AGENDA  
PLAN COMMISSION  
Board Room, 3rd Floor  
Arlington Heights Village Hall, 33 S. Arlington Heights Rd.  
Arlington Heights IL 60005  
April 23, 2025  
7:30 PM

- I. CALL TO ORDER
- II. ROLL CALL OF MEMBERS
- III. APPROVAL OF MINUTES
  - A. PC Minutes 4/9/25
- IV. PUBLIC HEARINGS
  - A. PC24-025 - 660 N. Ridge Ave - Arlington Ridge Center Building Addition.  
PUD Amendment & Special Use Permit Amendment to expand previously approved  
PUD & Special Use Permit, Variations
  - B. PC25-007 - 500 E. Miner St. - Recreation Park Phase II & III  
PUD Amendment & Special Use Permit for Phase II & III of Recreation Park,  
Variations
- V. OTHER BUSINESS
- VI. PUBLIC COMMENT

**Plan Commission  
4/23/2025**

**To:** Plan Commission  
**Prepared By:** Dan Osoba, Planner I  
**Meeting Date:** April 23, 2025  
**Date Prepared:** April 11, 2025

1 EAST ELEVATION  
1/8" = 1'-0"

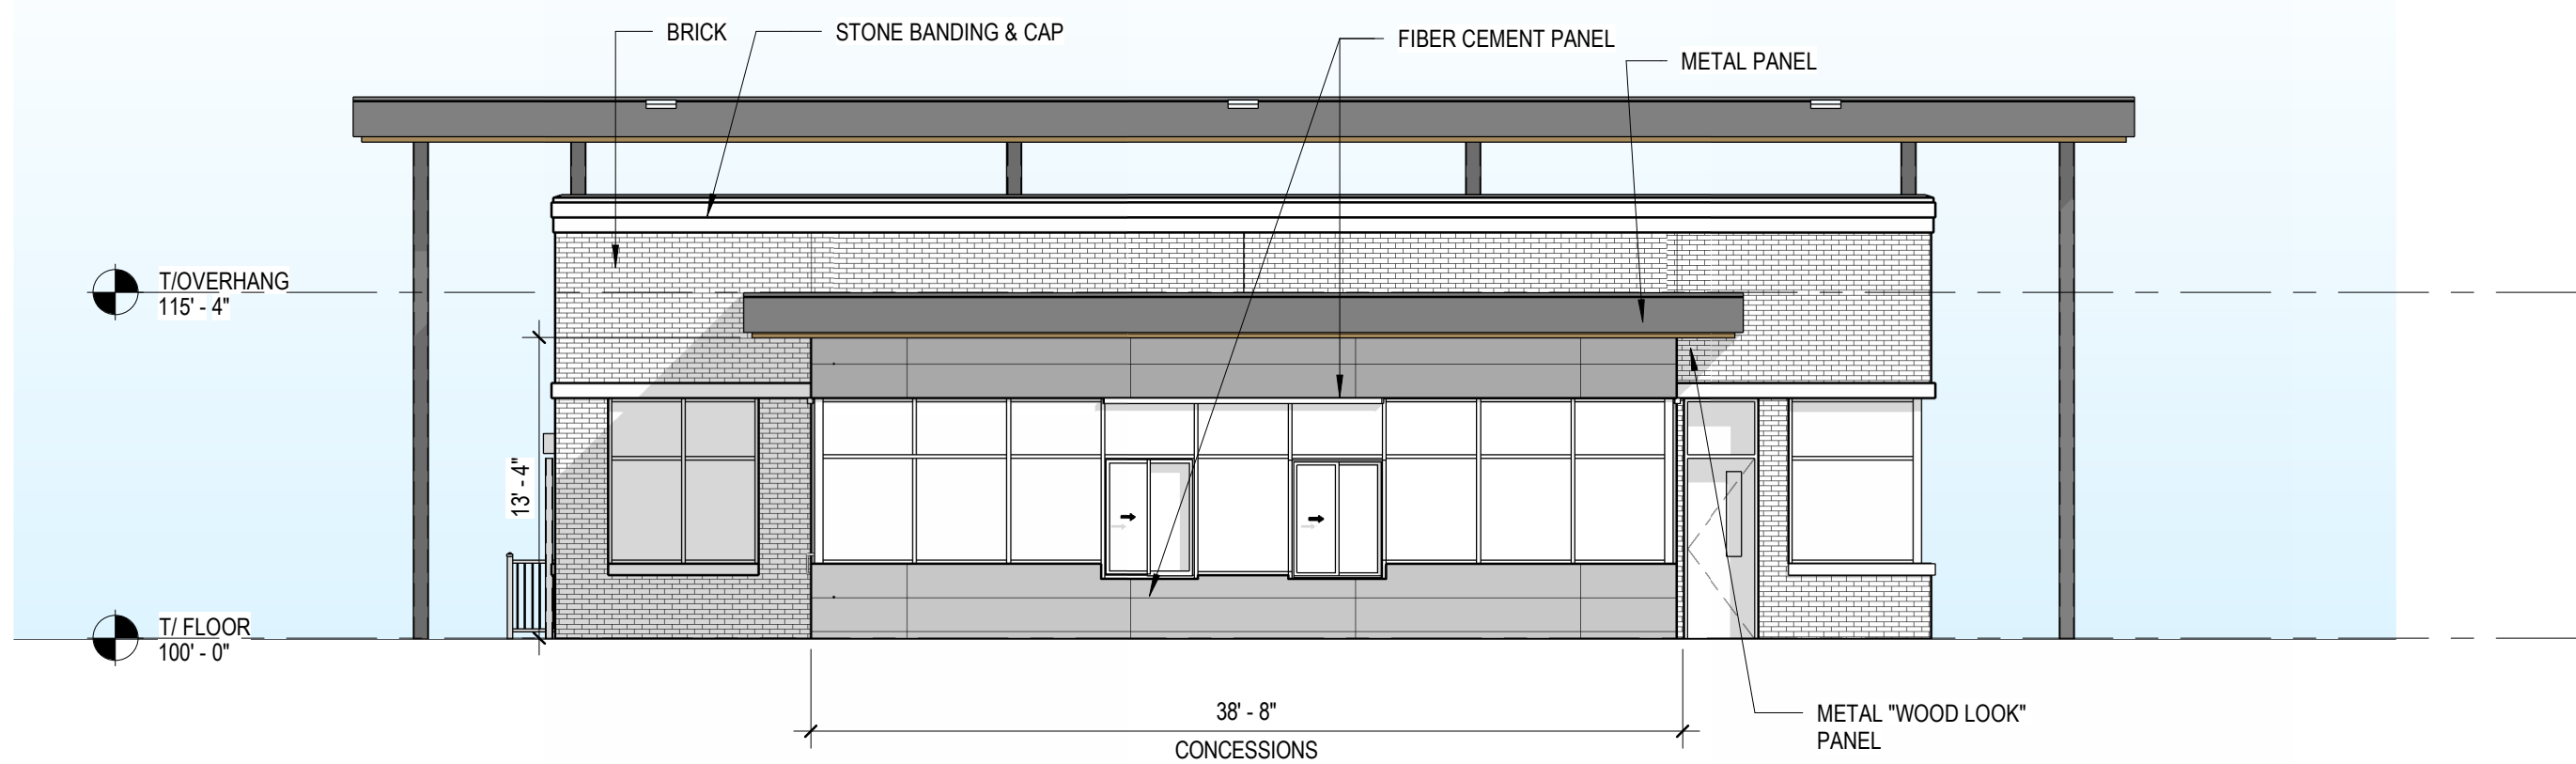
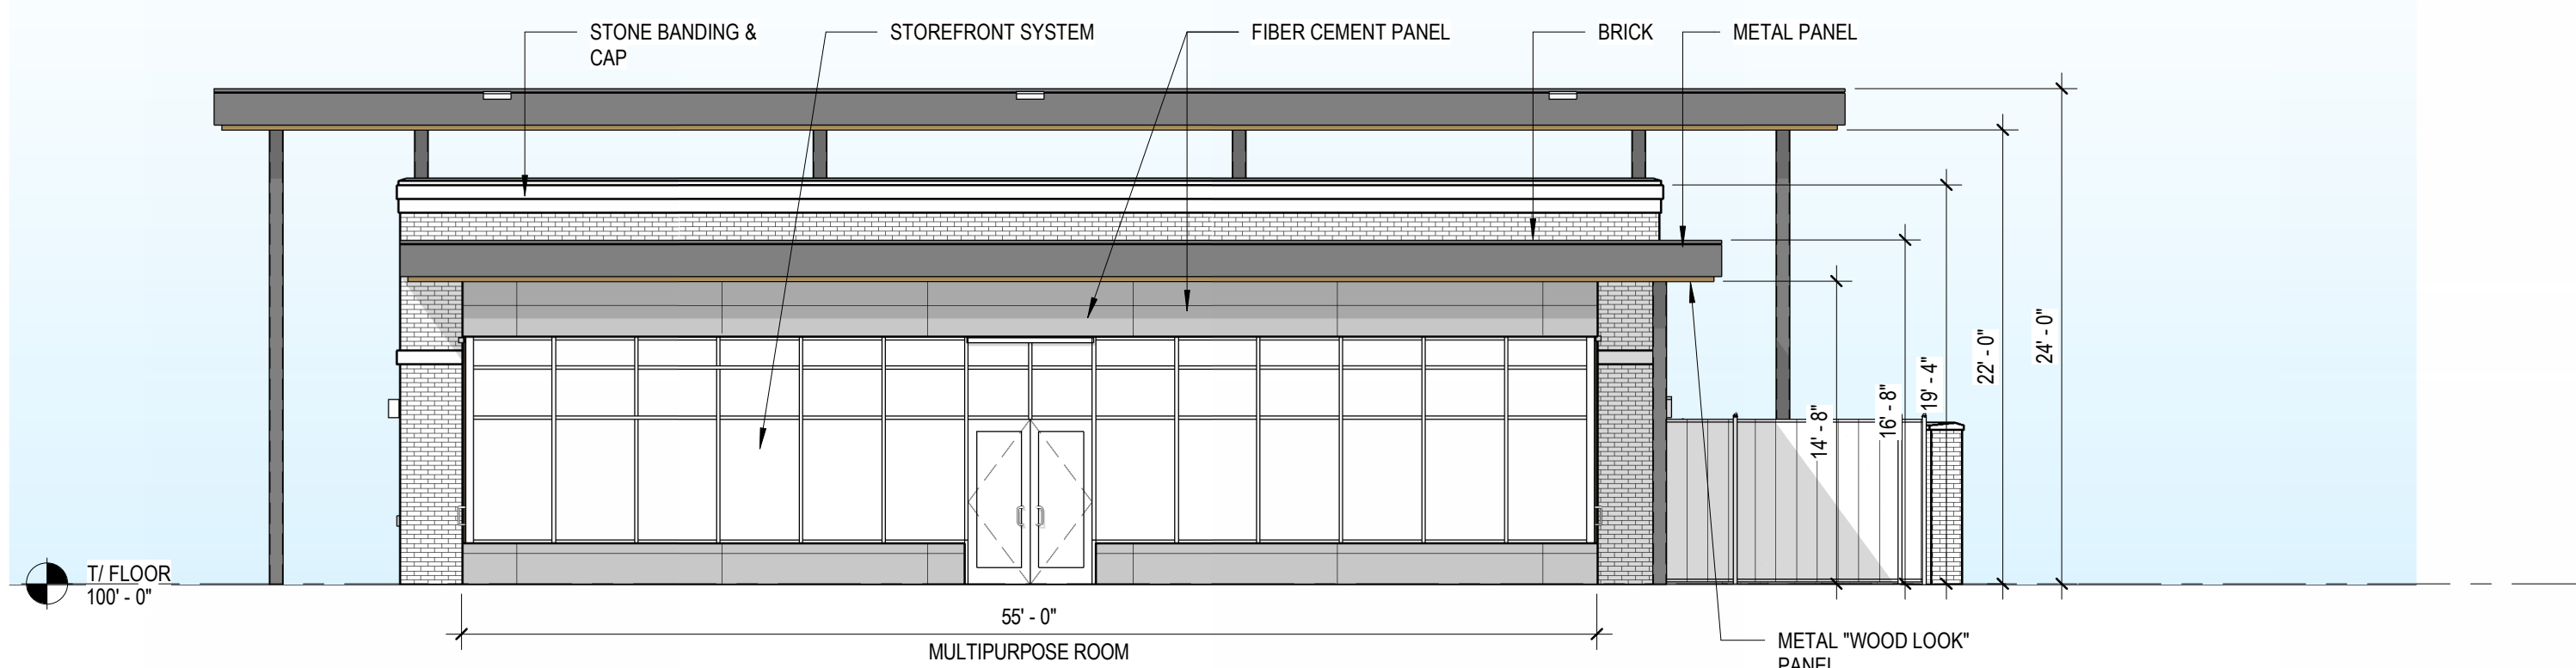
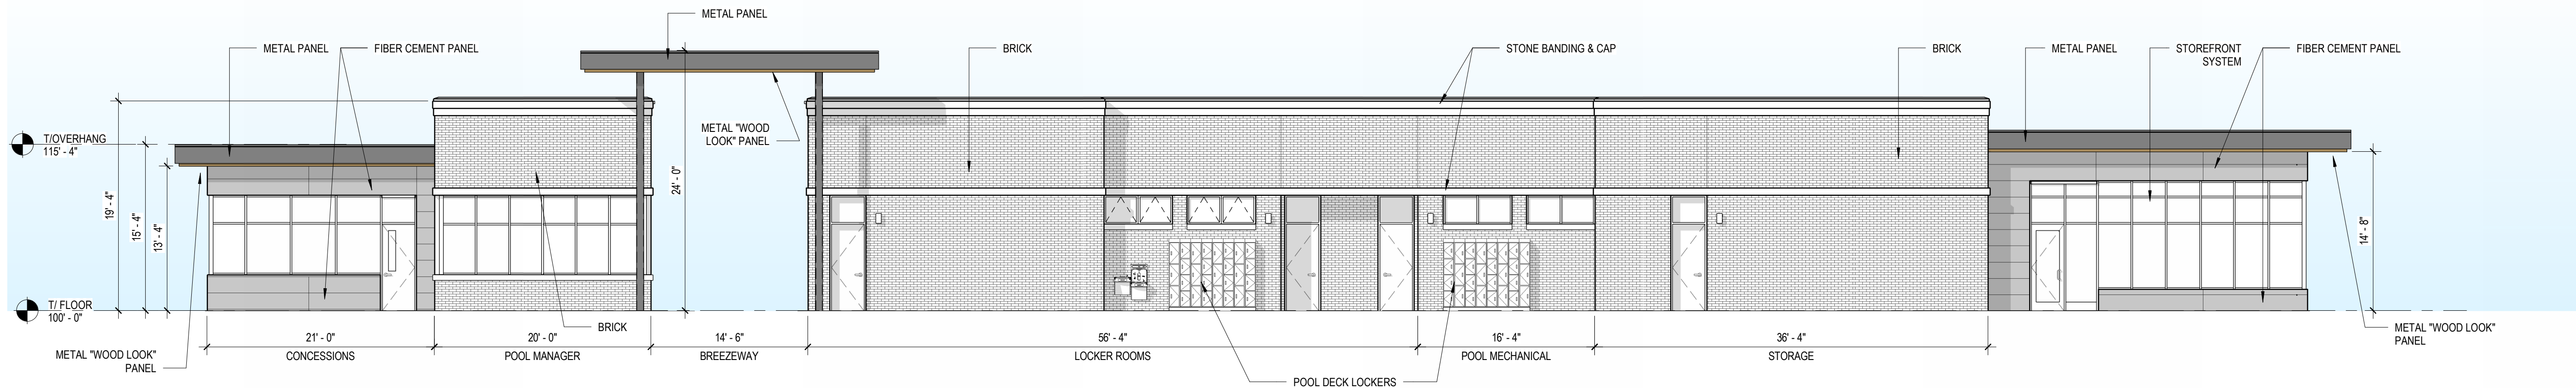
5. **IFC 2018 D105.1 Aerial Access Roads Where required.** Where the vertical distance between the grade plane and the highest roof surface exceeds 30 feet (9144 mm), approved aerial fire apparatus access roads shall be provided. For purposes of this section, the highest roof surface shall be determined by measurement to the eave of a pitched roof, the intersection of the roof to the exterior wall, or the top of parapet walls, whichever is greater. *Please provide drawings showing the height of the main building from grade plane. If it exceeds 30 feet, provide an autoturn diagram for AHFD Tower 133 and diagrams showing compliance to items 6 & 7 below.*

**Response: Height information for the Community Building has been added to the Building Elevations on sheet A6. The height to the existing eave of roof of the Community Building is ~27'-9" and therefore Aerial Access Roads are not required.**
